KMR.CDD.LyQ.1918.02

ORDER UNDER SECTION 96 (2) OF ACT, III OF 1901.

SHOWING PROPOSED STABLES
ON PLOT NO: 445 SHEET K7
LYAREE QUARTER
SCALE 3 FT = 1 INCH

PLAN SHOWING PROPOSED BUILDING TO BE BUILT ON PLOT NO 254
SHEET K-7 LYREE QUARTER

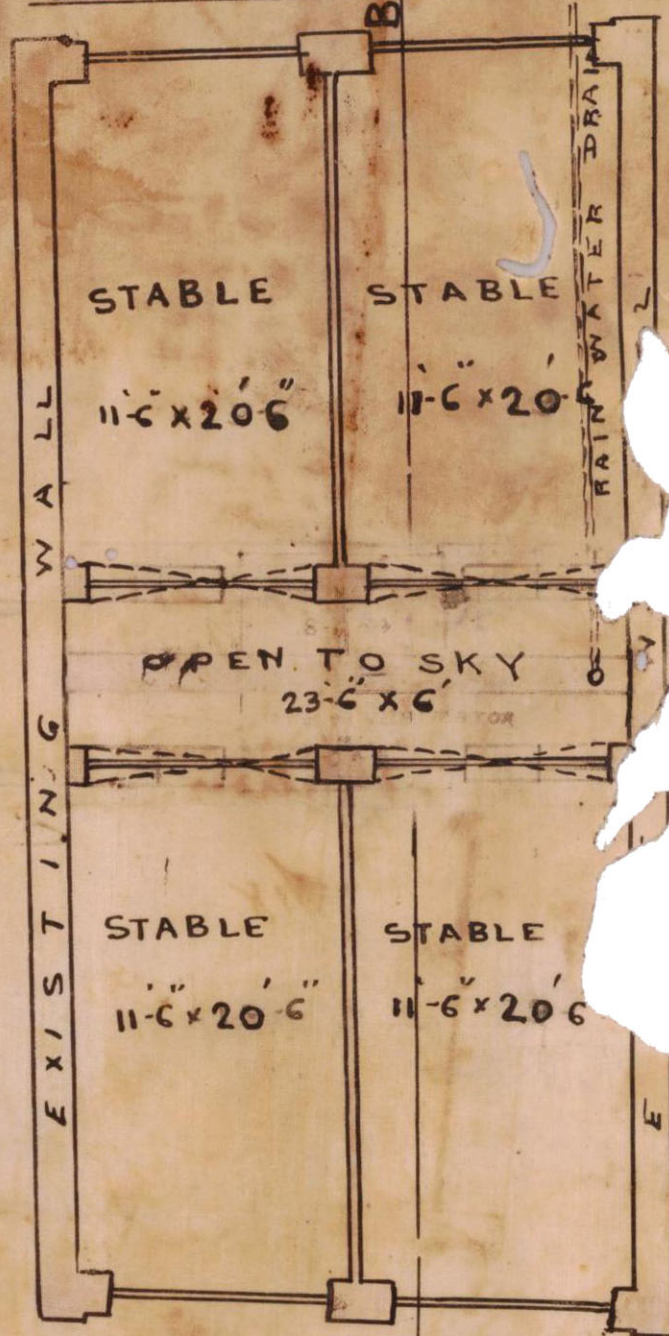
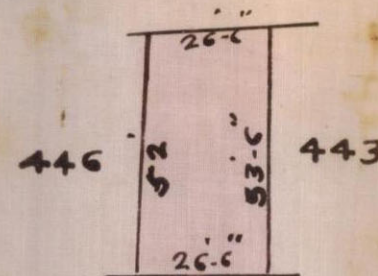
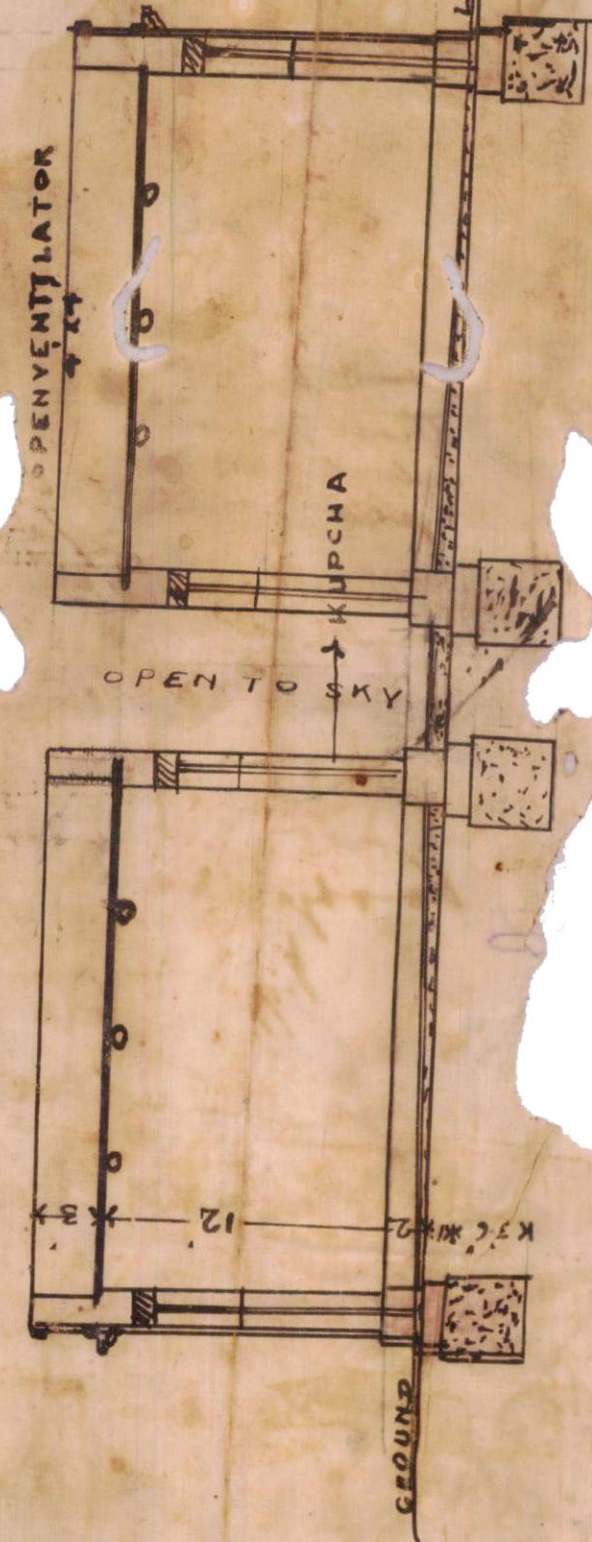
With reference to his
July 1918 ~~requesting for~~ resubmitting
posed stables on plot No. 445, K - 7
Manghraj Tulsidas is informed that as
on the plan must be left open to sky
ventilation for the stables. The plan is returned with
for amendment.

an area as shown in red on
the plan must be left open
to sky to provide suitable
ventilation for the stables

Stables are now
well ventilated

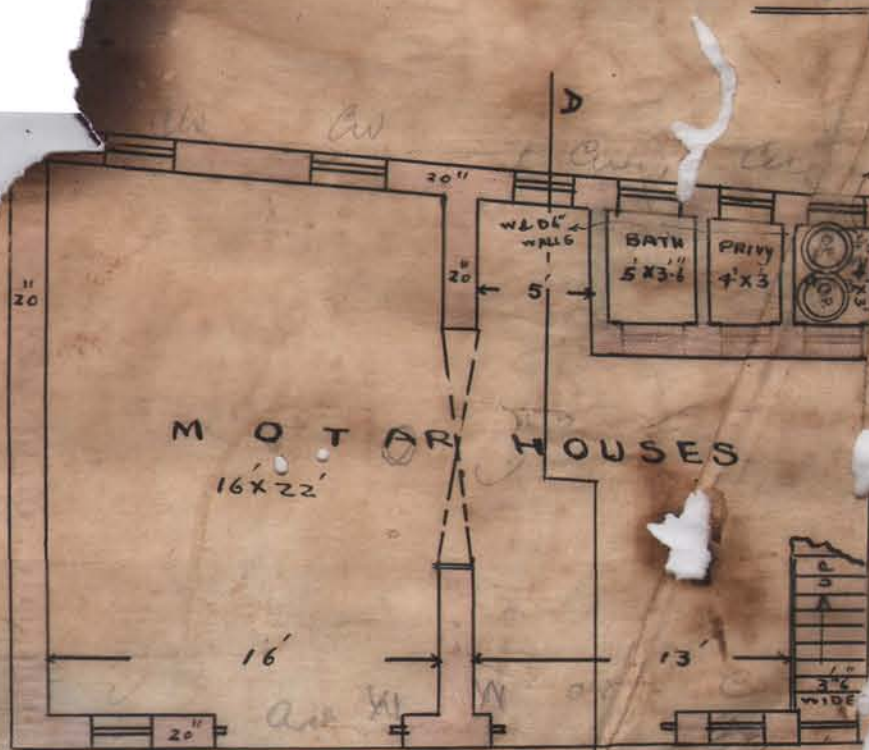
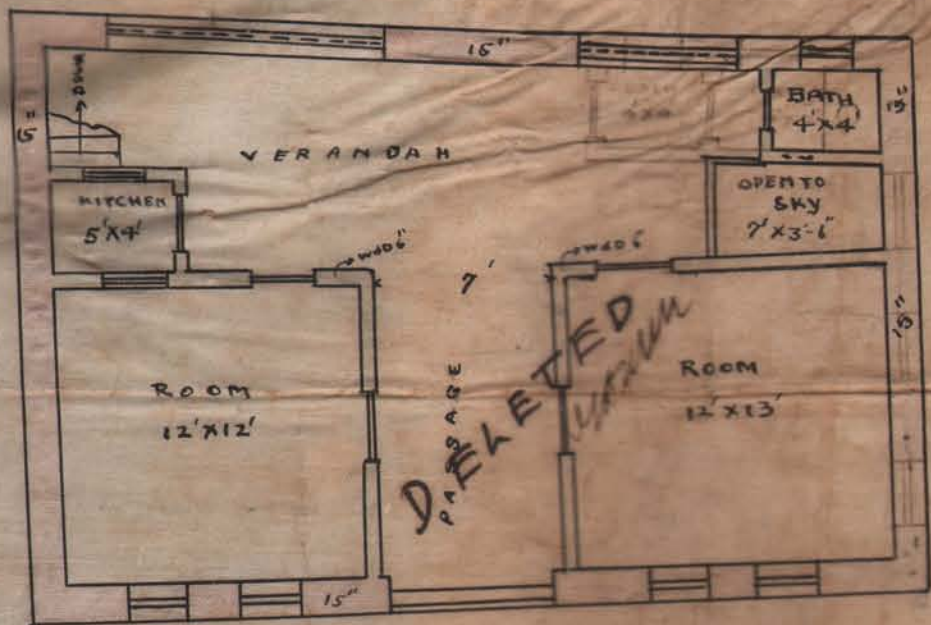
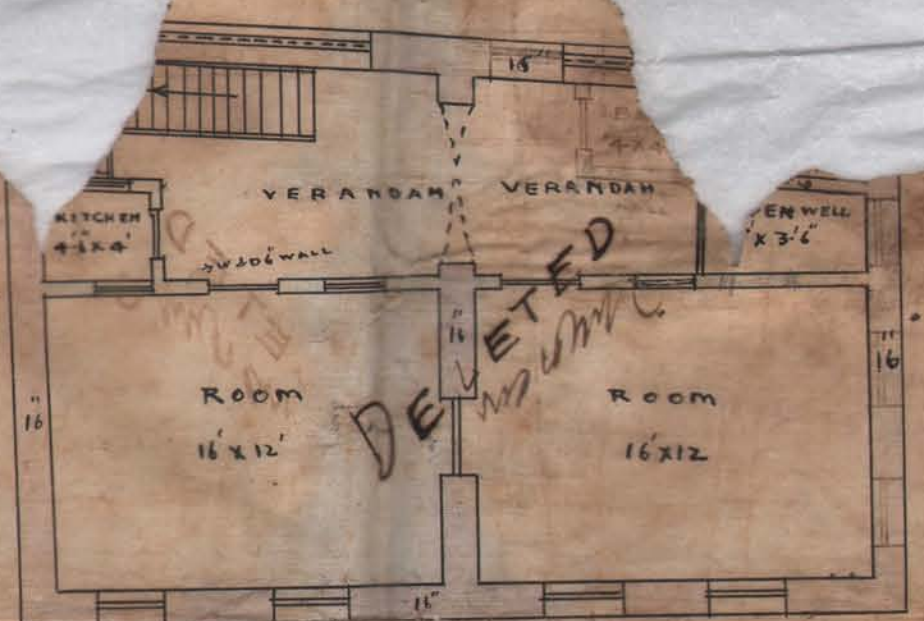
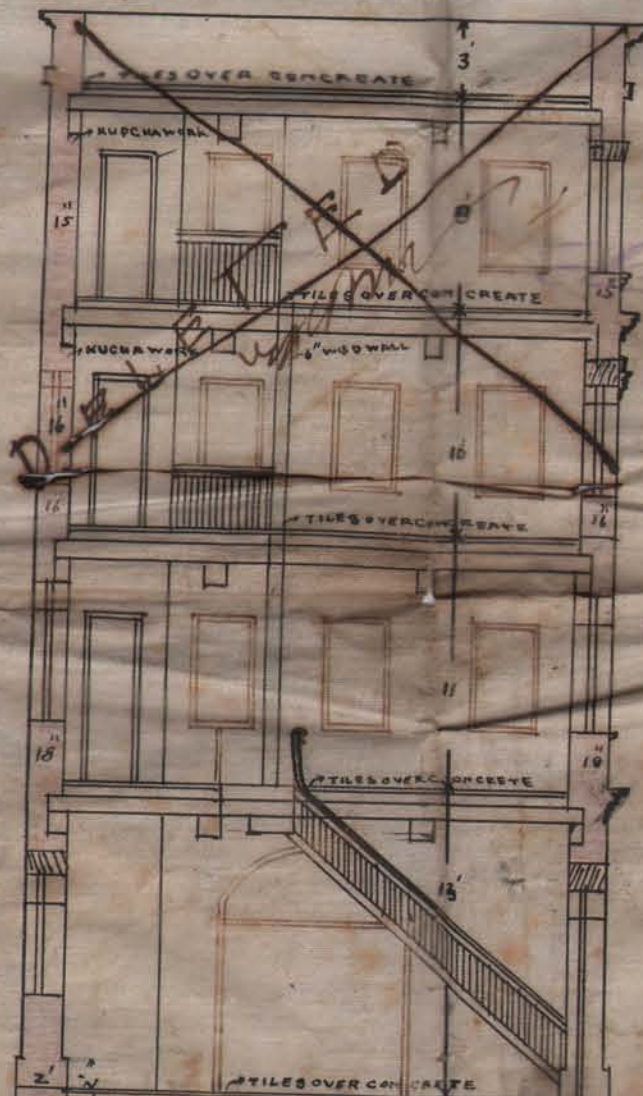
With reference to his letter of July 1918 submitting plans of the proposed building to be erected on plot No. 254.K.7 Hyari Chowk, Karachi, Mr. Chetakram is informed that the plan submitted is not approved on the East on Municipal saleable land. The width of the street allowed. The width of the street will only permit of a two storied building. The foundations are not strong enough for a four storied building. The plinth level must be 2' above ground level. The subsoil water level must be shown on the plan. The staircase is not suitable for a four storied building.

*It's doubts if a piece a building
four stories high should be permitted
it by an architect. Heavy arrangements
for four stories are not satisfactory*

Building Surveyor's report Sir, I beg to report that
plan is incorrect. there is no plot provided
provisions contrary to rule. Kutchha
3 1/2 high are provided. Requested

The plan shows windows opening on the
East on Municipal Salable land which cannot
be allowed. The width of the street to the North of
the plot will only permit of a two stories
building being erected. The foundations are not
strong enough for a four stories building. The plinth level
must be 2'-6" above ground level. The subsoil water level
must be shown on the plan.

With reference to your me
dated 13th August last re
proposed building on
sheet K-7 Lyane Q.
the honour to & business
plans, according to the
accordance with your
instructions in the Off
9th windows on the main
land have been detail
on the 2nd & 3rd floor
level is shown on the
increased to 4' width. You will
not delay in approving the same. I
beg to

PLAN
SHOWING PROPOSED STABLES
ON PLOT NO: 445 SHEET K7
LYAREE QUARTER
SCALE 8 FT = 1 INCH

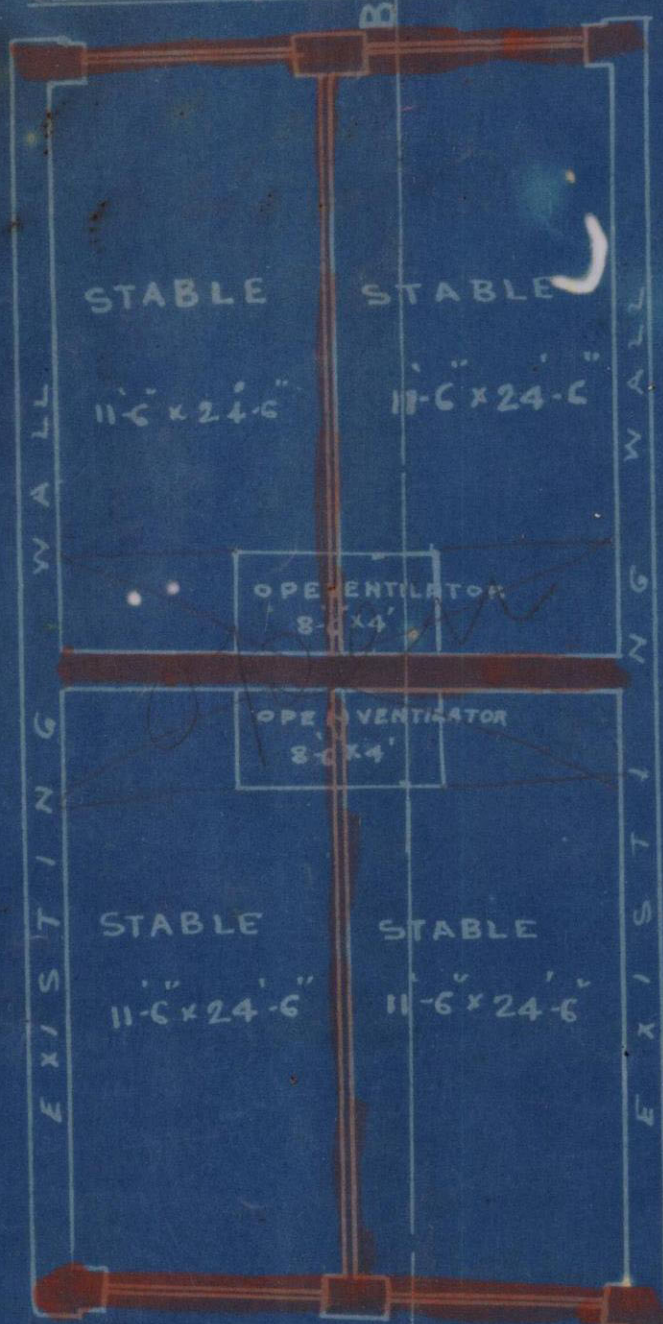
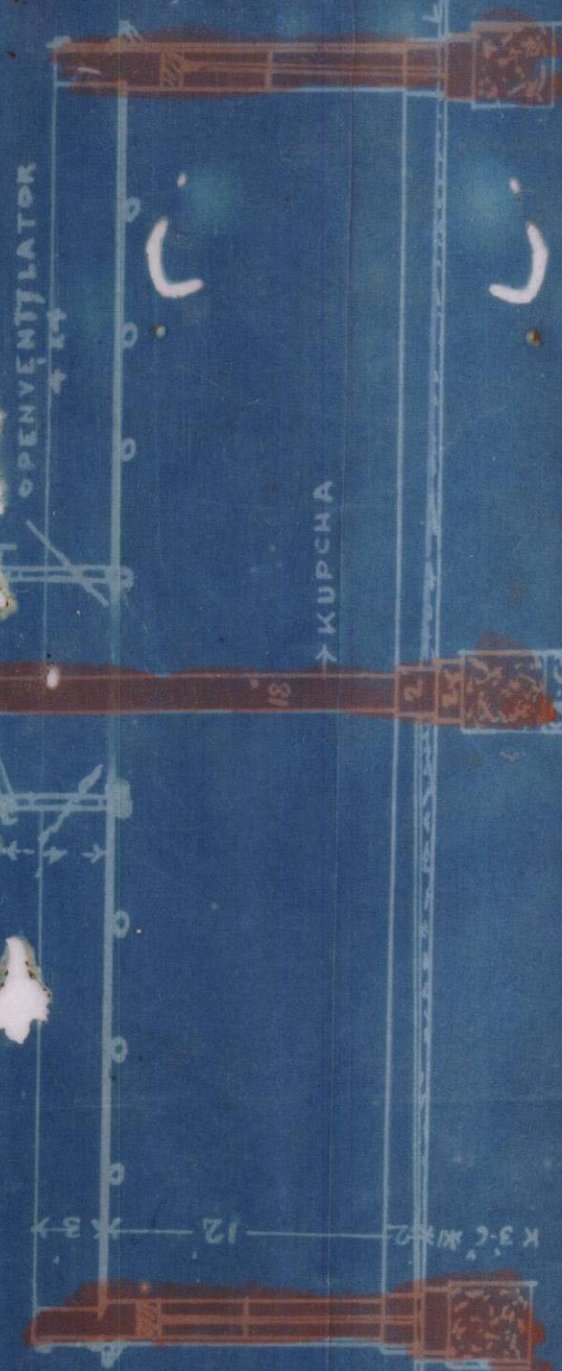
that in order to

the plan must be left

to provide suitable ventilation for the

SHOWING PROPOSED STABLES
ON PLOT NO. 445 SHEET K7
LYAREE QUARTER
SCALE 8 FT. = 1 INCH

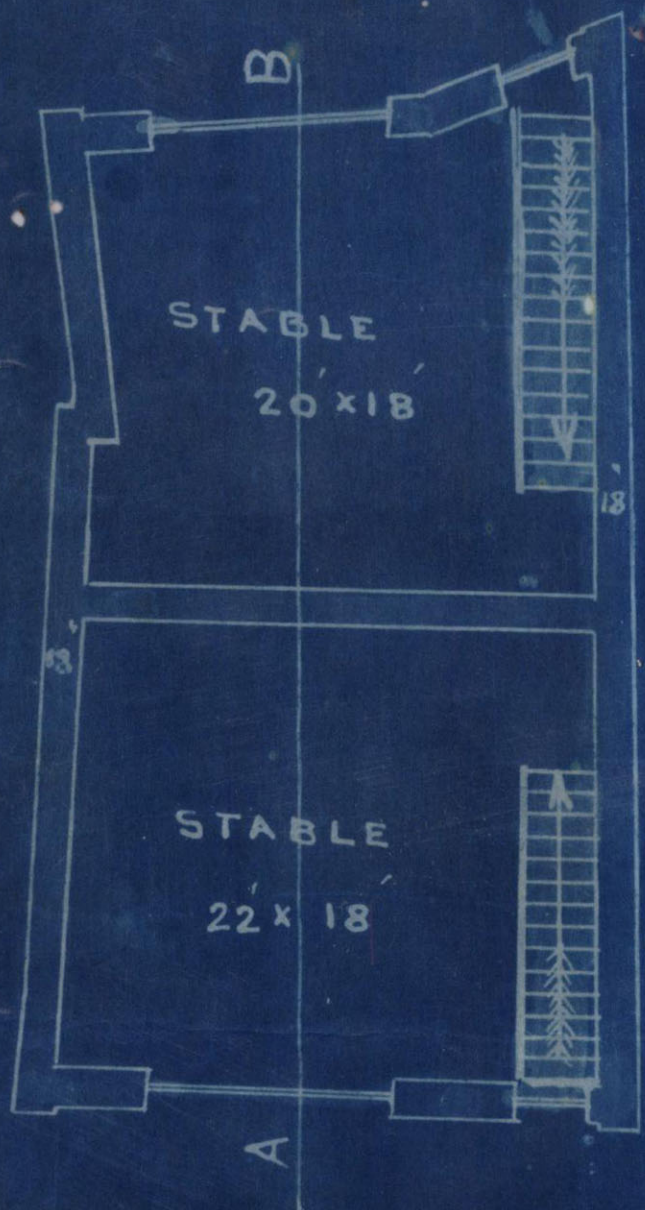
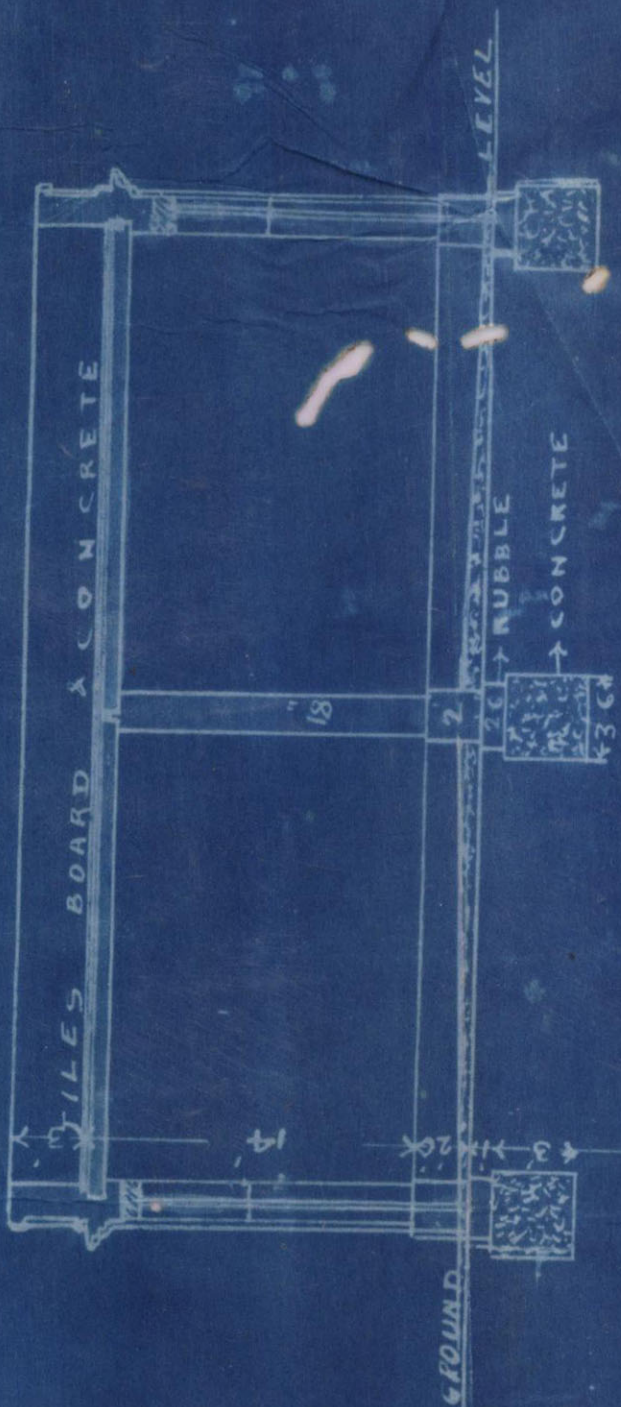
With reference to his application dated 12th May 1918 and received on the 15th May 1918 with a plan of the proposed building on plot No. 445. K. I. Q. quarter Mr. Menghraj Tulsidas is informed that the plan is designed as stables. No means of ventilation is shown. He must state for ^{what} use the stair-cases are to be

remarks:— *It is not understood why the
staircase is provided. Is there to be a
loft constructed? if so, it cannot be
permitted.*

I hereby report that if the staircases shown on the plan are deleted there appears no objection to approve the plan.

seems no objection provided a proper ventilation is provided.

The plan is not properly designed as a stable. No means of ventilation is shown. For what use are the staircases to be put.
